ADDENDUM – 1

KENNEDY MANOR WASTE LINE REPLACEMENT LOBBY AREA

Project Site:
175 Broad Street, Pawtucket RI 02860

SHEET TITLE
KENNEDY MANOR
LOWER LEVEL PLUMBING PLAN

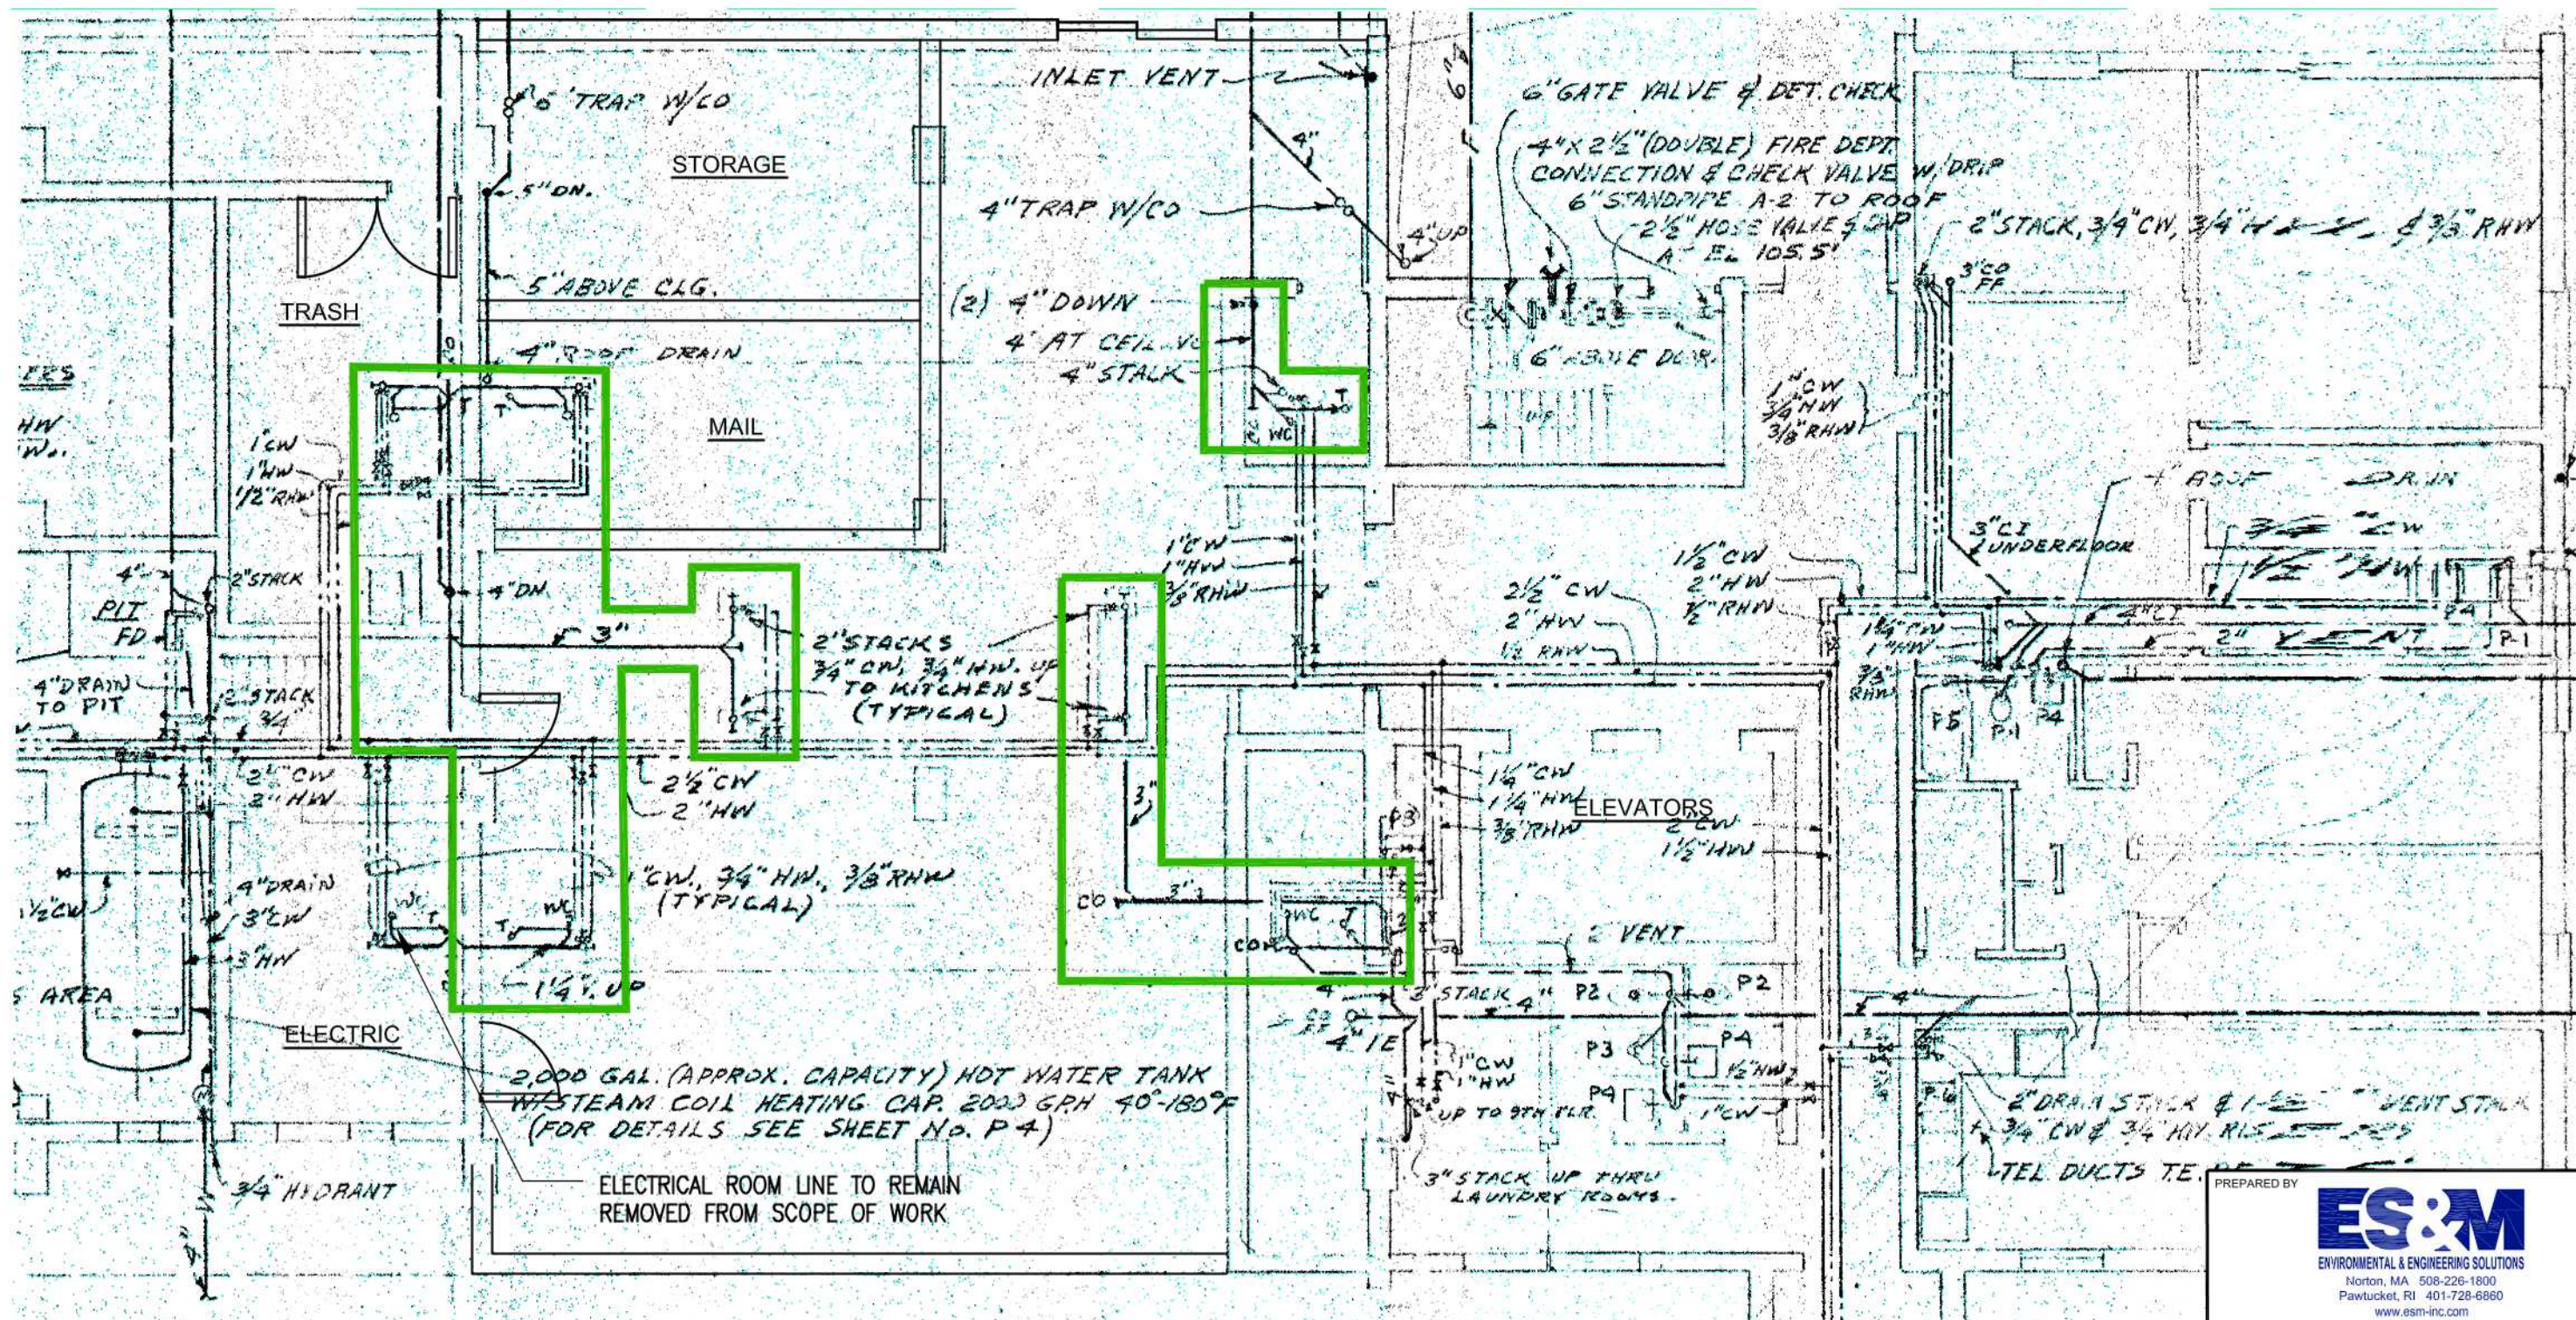
Item 1: Please disregard the waste line replacement for the area located within the electrical room, this area has been removed from the scope of work. Please see attached revised plans.
